Grimes Planning and Zoning Commission

Planning and Zoning Commission May 2, 2023 @ 5:30 p.m. **In Person at Grimes Community Complex, 410 SE Main Street, Room 202**

The Development Services Department is in receipt of a proposed Site Plan for the Green State Credit Union. Based on the review of the provided submittal materials, staff have the following comments:

CONCEPT PLAN

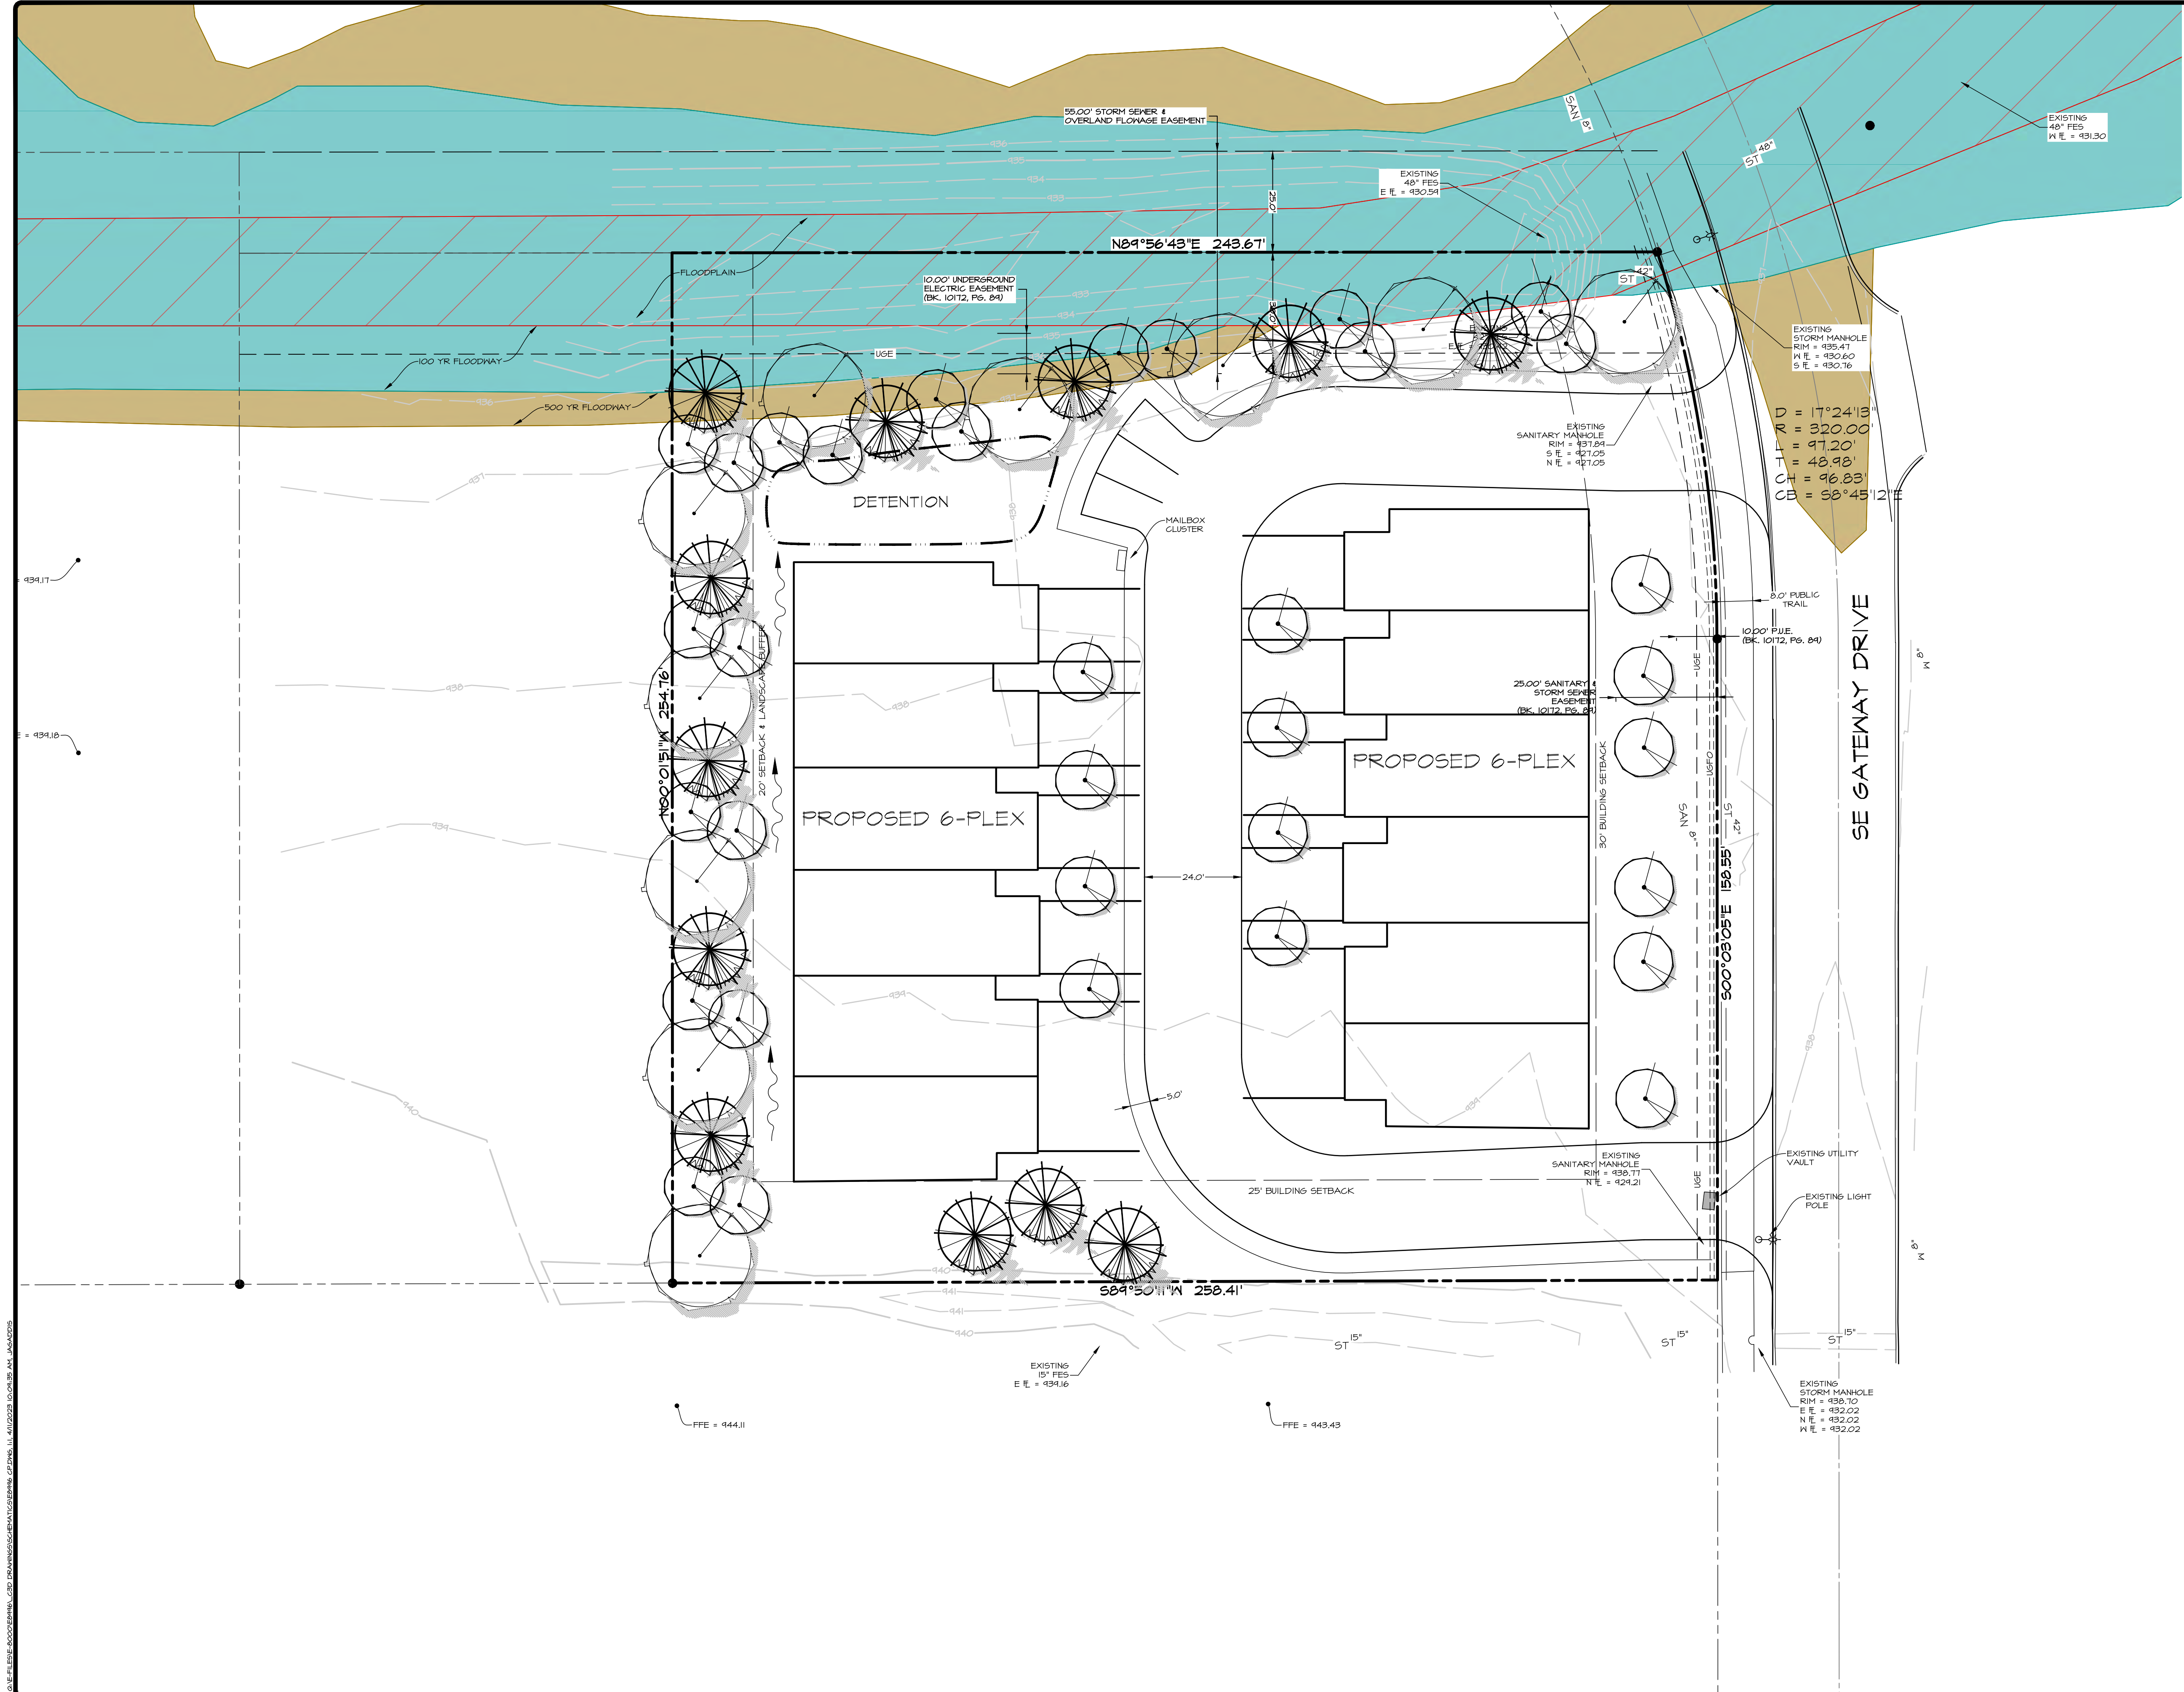
- ~~1. Please update the landscape buffer plantings to match the development agreement.~~
- ~~2. Stormwater detention cannot be located within the floodplain.~~
3. Detention will likely cause a few of the units to be removed. Depending on the number removed, the zoning may need to be changed to R-3 Medium (8 du/a) instead of R-3 High. **The zoning request should change to R-3 Medium due to the density of the concept which is more realistic due to site circulation and, detention, and floodplain.**

- ~~4. Please show required visitor parking (1 space/5 units).~~
- ~~5. Please change the 5' sidewalk along SE Gateway Dr to 8' trail. Shift the trail to be located within the right of way.~~
- ~~6. A minimum of 40% open space is required. Please revise plan accordingly.~~
- ~~7. The unit on Lot 1 doesn't appear to meet the setback. Please adjust.~~
- ~~8. The fence along SE Gateway Dr is not permitted. Fencing is not allowed within the front yard. Please remove.~~
9. Provide concept elevations for the buildings, including the front door elevations for the units facing SE Gateway Dr. The elevations need to meet the R-3 architecture requirements (See Section 12-13-1 zoning ordinance). A minimum of 25% of all sides of the buildings shall be masonry material. **Please provide.**
10. **Revise the rear setback to 30'. The side setback is 7'.**

1. Discharge into the floodplain will require a 404 permit and City of Grimes floodplain permit.
2. The driveway into the site will need to be elevated above the floodplain.
3. Staff would like to see turning movements with the site plan submittal. The curves on the private driveway look tight.
4. Is the property proposed to be platted into individual lots? This will determine how utilities will need to be provided for the units.
5. A swale will likely be required along the west side of the site. How will a buffer be proposed within a swale?
6. There appears to be a utility vault in the location of the south driveway that will need to be relocated.

7. A streetlight will also need to be relocated due to location of the south driveway.
8. The square footage of both buildings would require fire suppression.
9. In looking at the building floor plan, is there a bathroom right off of the garage?
10. Label proposed location for the mailbox cluster. The cluster will need to be provided along an ADA accessible route.
11. Landscaping will need to be provided in accordance with the Highway 141 Corridor District requirements. Buffer landscaping can count toward the overall open space planting requirements.
